Cascades Summitin Village 21. Parcel L Update #1

CITY OF LAS VEGAS		DATE:
INTER-OFFICE MEMORANDUM		April 27, 2020
TO: Land Development Services Department of Building & Safety		FROM: Jennifer Shinn, P.E.  Flood Control, Engr. Associate Department of Public Works
SUBJECT:	Drainage Study for:	
	Cascades Summerlin Village 21 – Parcel L Update #1	
Cross Streets:	SWC Desert Foothill Dr. & Kindle Corner Ave	Howard Hughes Company, LLC
File Number:	F:\Depot\DSMemos\DS5157E.doc	Bart Anderson, P.E., DevCo
Parcel Number:	137-27-510-001	CCRFGD
Zoning Action:	TMP-76889	
FEMA Flood Zone	YES NO X	
Proposed Storm Drain	YES X NO

**UPDATE #1 TO THE
TECHNICAL DRAINAGE STUDY
For
Cascades (Summerlin Village 21 – Parcel L)
(APN: 137-27-510-001)**

**Re: Update #1 to the Technical Drainage Study for Cascades (Summerlin Village 21 – Parcel L)
(PHYD: 20190801)**

C5

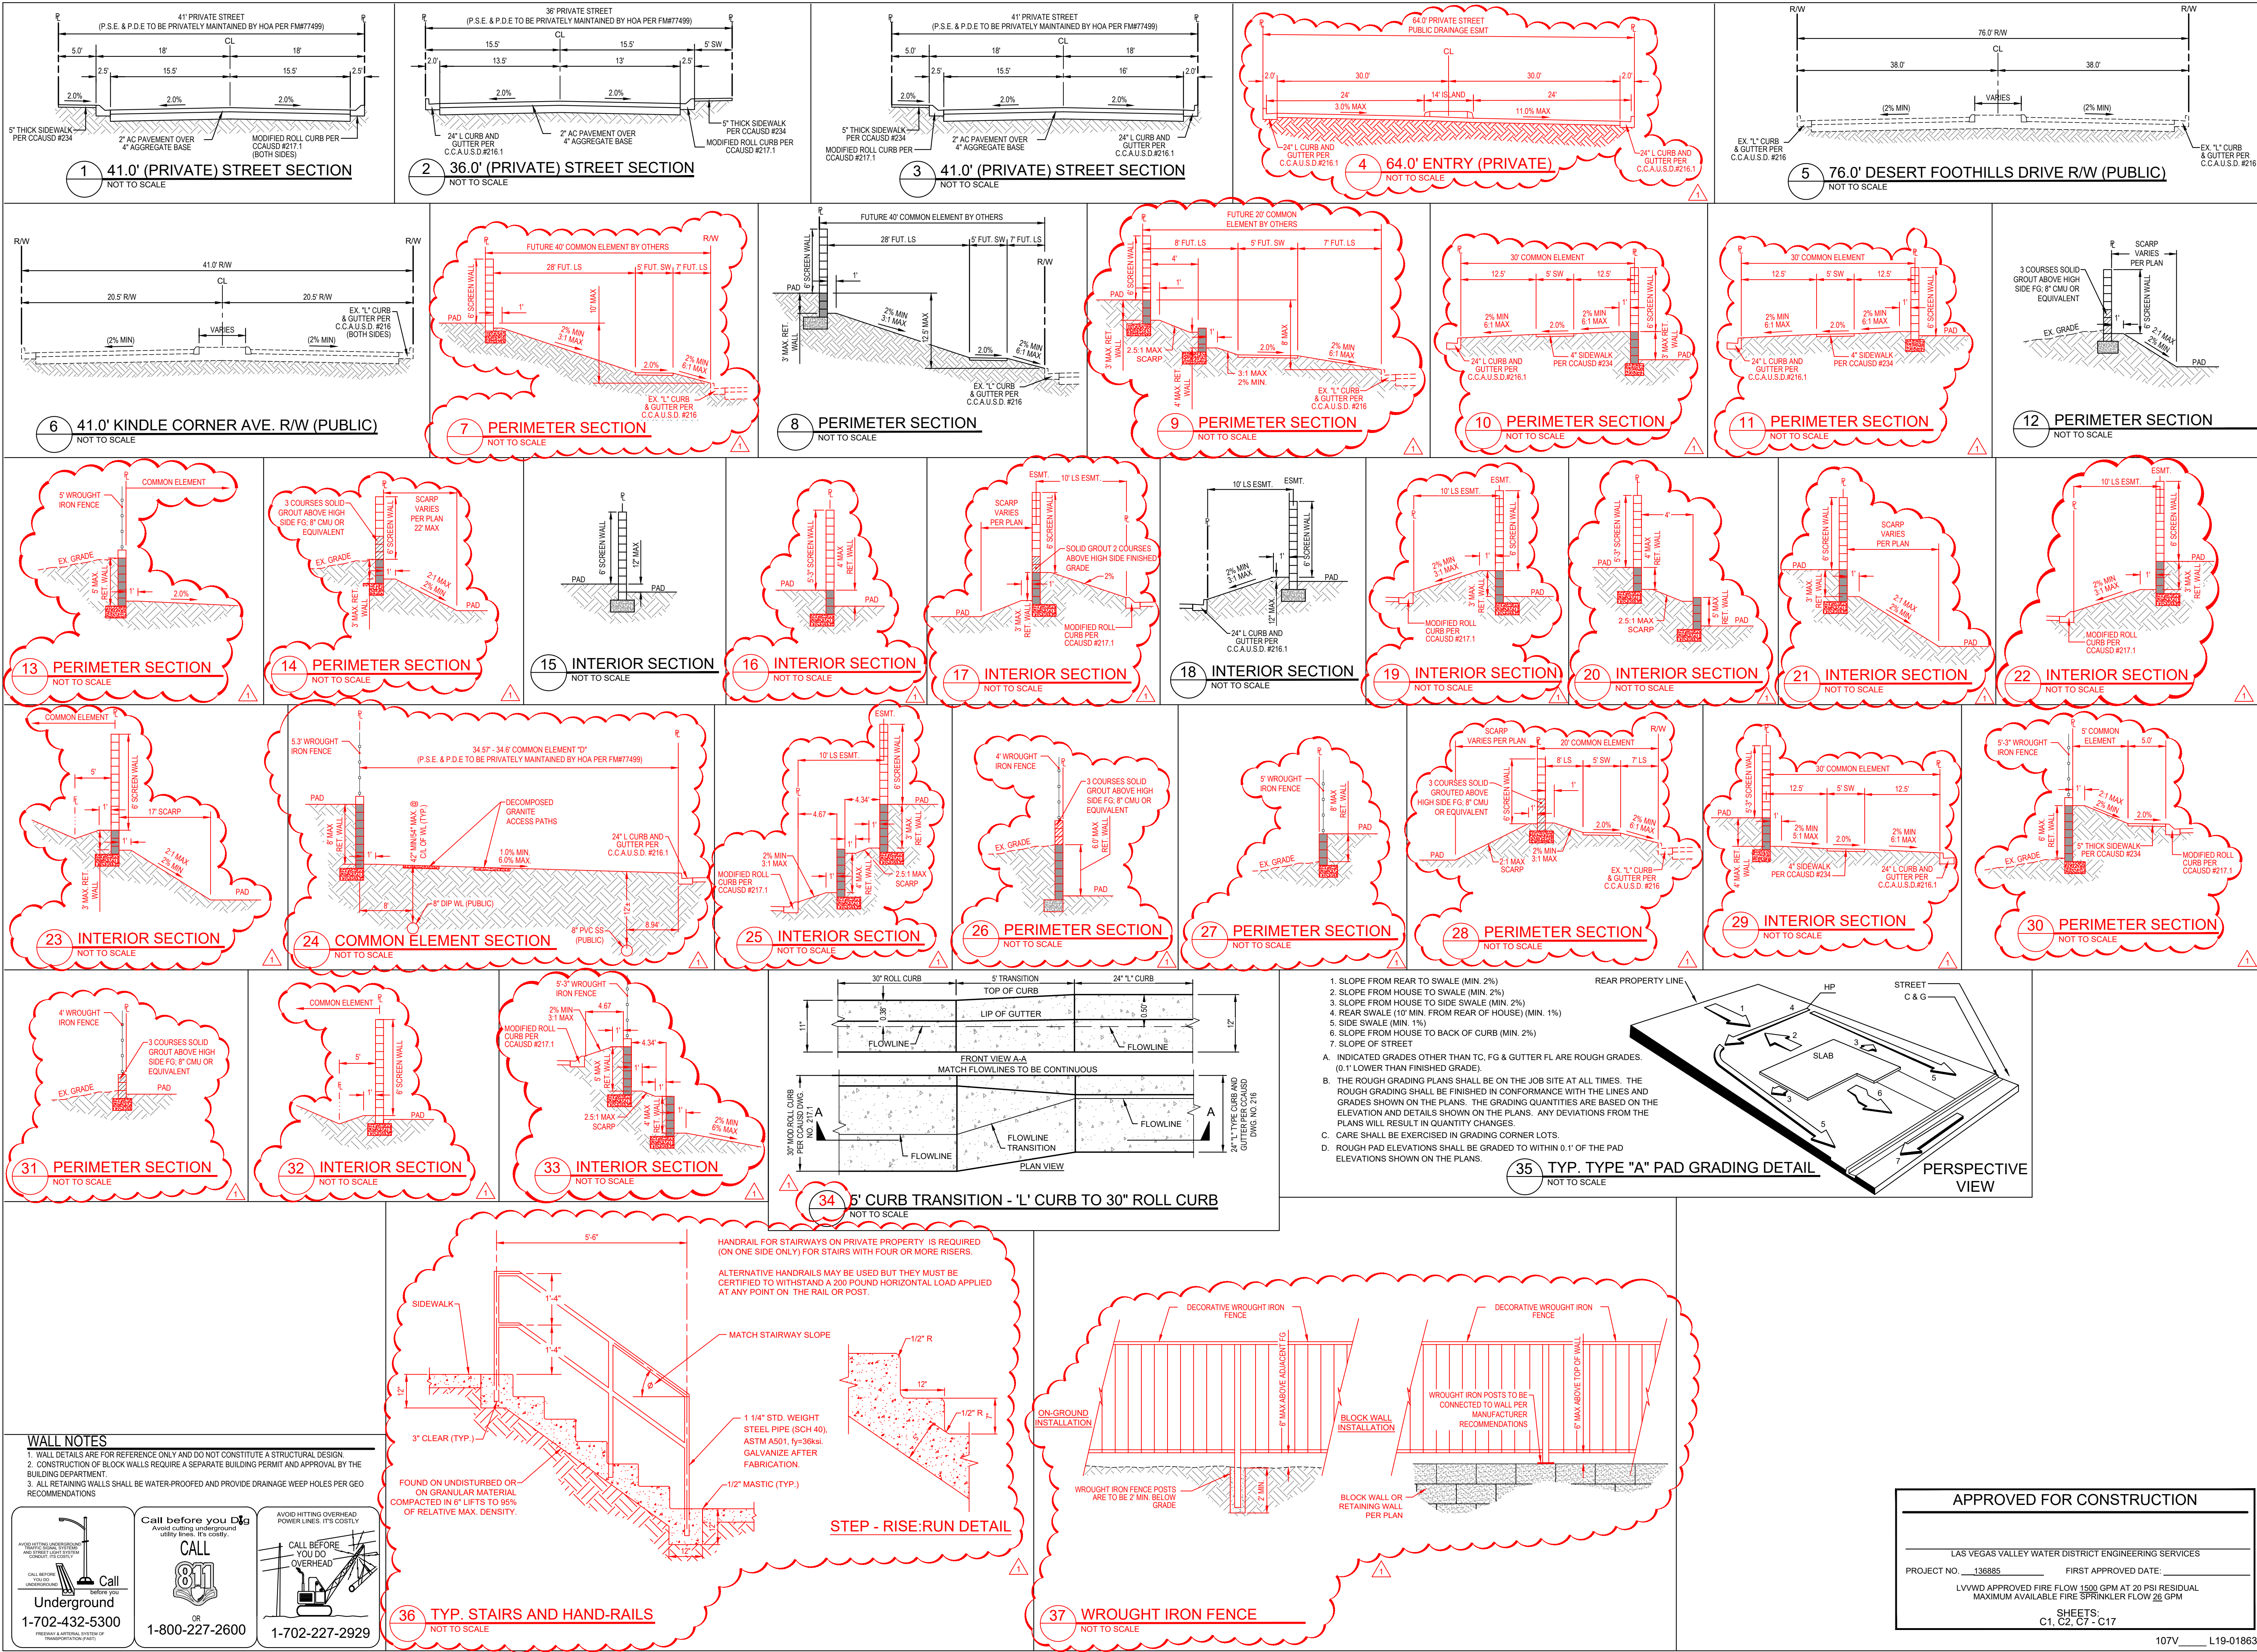
- Second Request: Sheet C5:** It appears that Common Element "D" is composed of two portions, a 33.71' drivable access and a 21.5' drainage easement. However, it was not demonstrated that the 100-year flow will be totally contained in the 21.5' drainage easement. If such is the case, the whole Common Element "D" shall be dedicated as a Public Drainage Easement.

DATE	01/28/2020
DRAWN	RLS
DESIGNED	RLS
CHECKED	DCL
PROJECT #	WLH011901
SHEET TITLE	DETAILS
SHEET NUMBER	C6

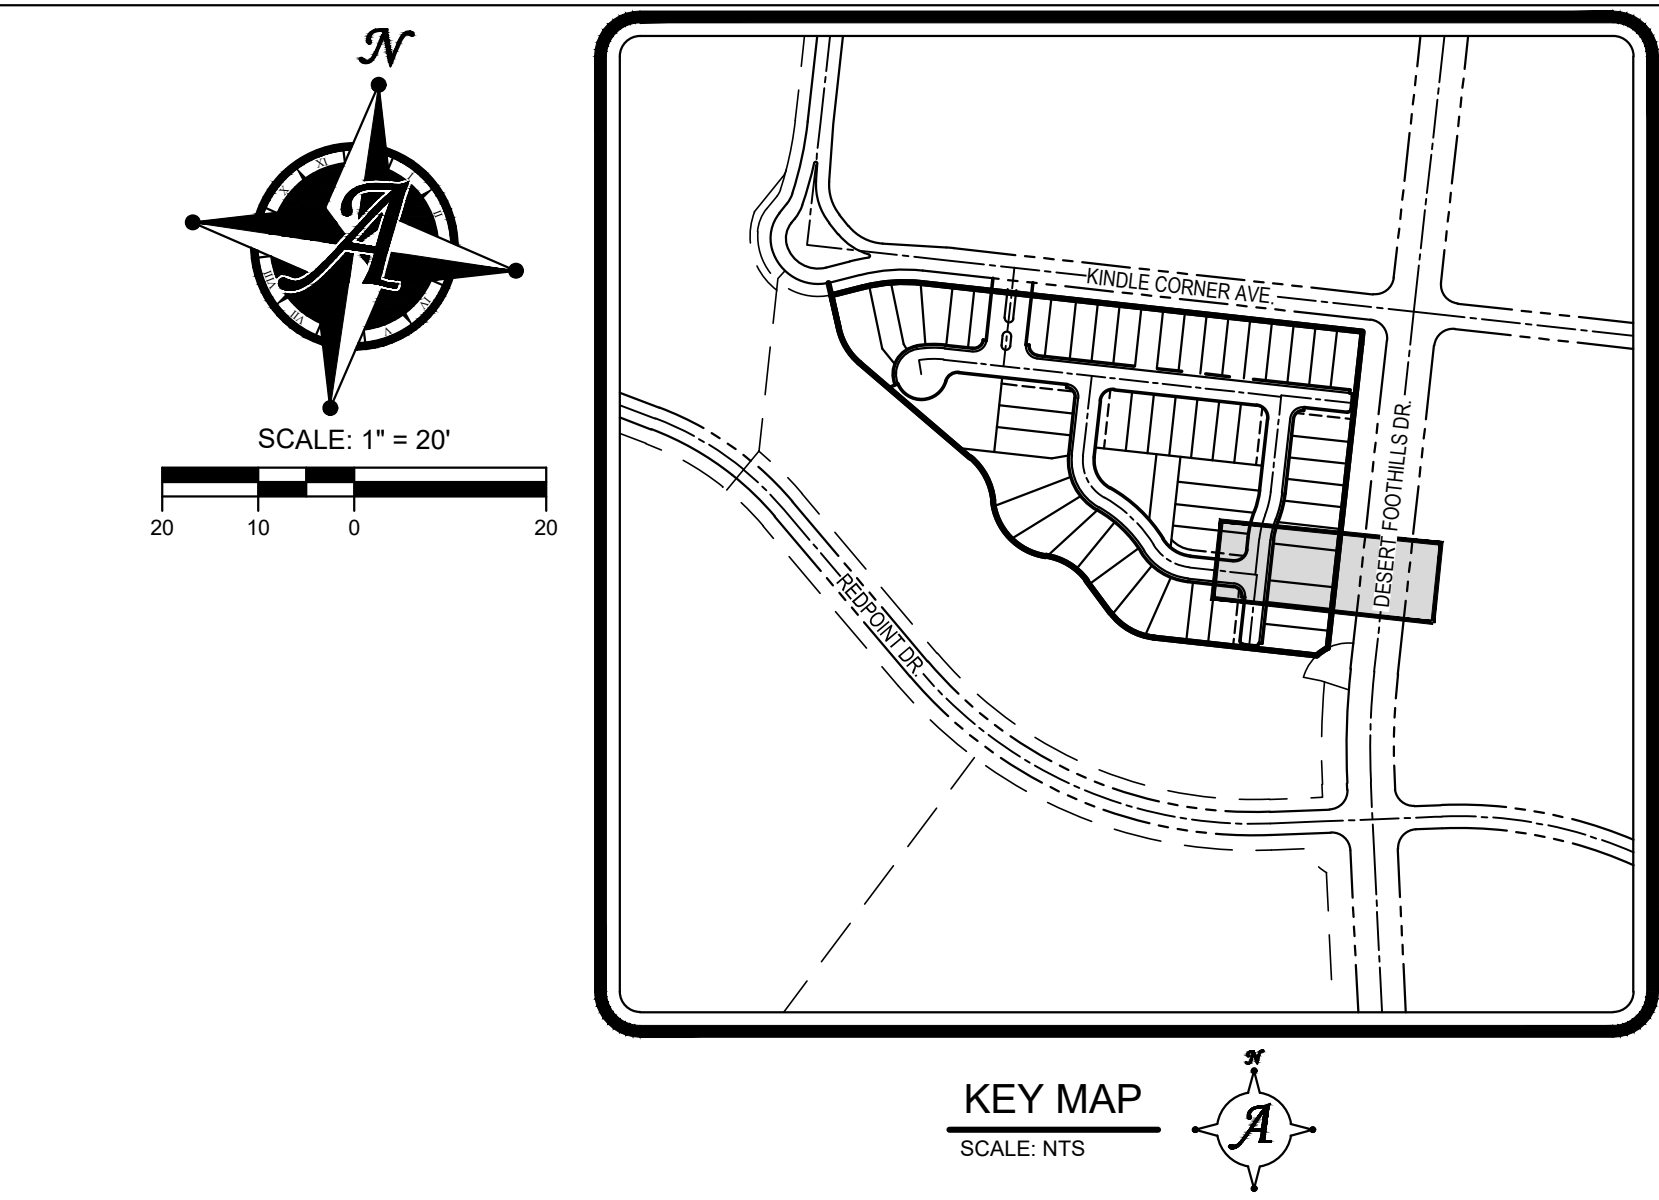
The revised Detail Section 24/C6 does not show the extent of the proposed public drainage easement (privately maintained). Review and revise accordingly.

4. *Revise Detail Section 29/C6 to clearly show that the bottom three courses of the wall are 8"-CMU to be solid grouted.*
